7.06.20	CHANGE AS PER ECN 20-063	A
DATE	DESCRIPTION	REV.

KEYSTONE ELECTRONICS CORP.			
www.keyelco.com • NEW HYDE PARK, NY 11040 • Tel (516) 328-7500			
PART NAME BATTERY CONTACT, SURFACE MOUNT			
MATERIAL .010 [0.25] TH'K ANNEALED SPRING STEEL			
FINISH MATTE TIN PLATE		DRN BY NT	DATE 7.28.09
		APP'D RH	SCALE 3X
TOLERANCES	INCH [MM]	CODE	DWG NO.
DECIMAL	±.010 [±0.25]	C	5330
ANGULAR	± 1°		
UNLESS OTHERWISE SPECIFIED

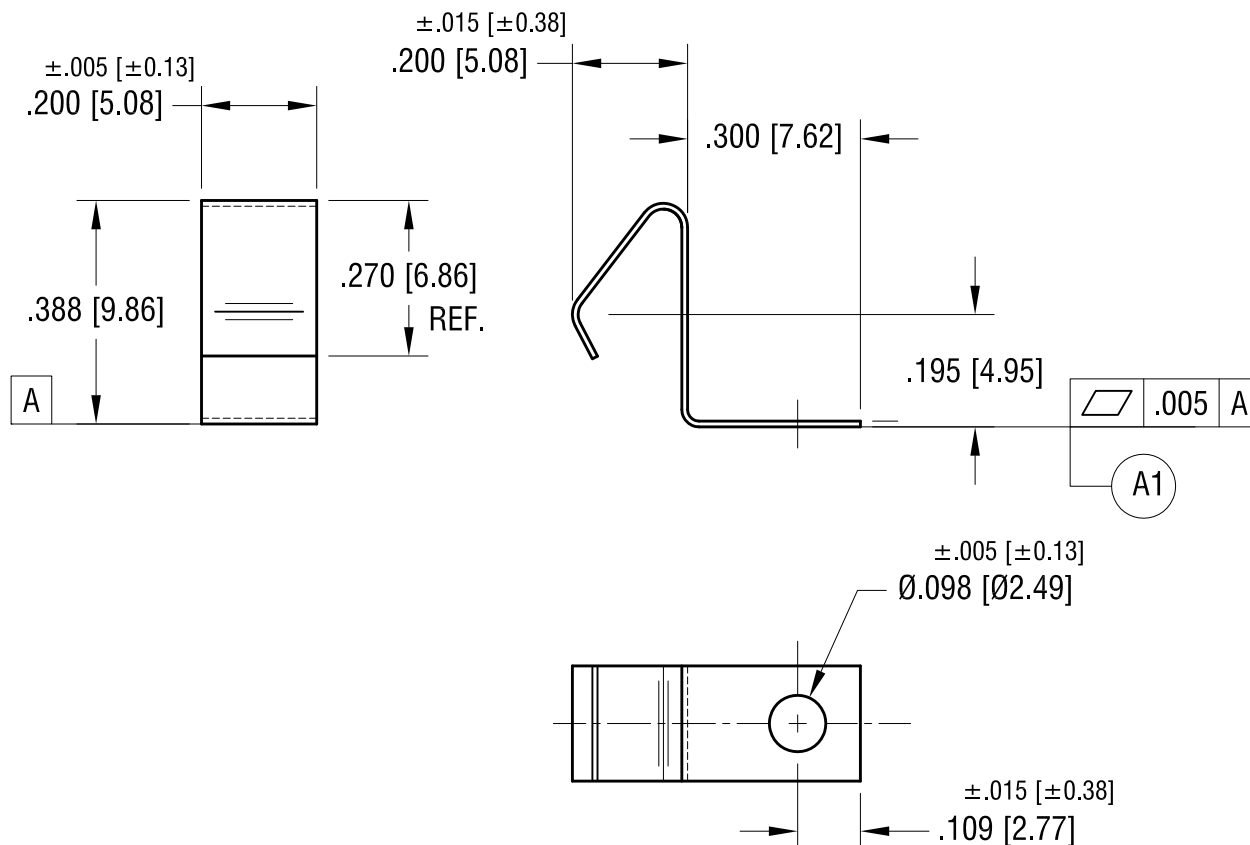
ADD FLATNESS (A1)
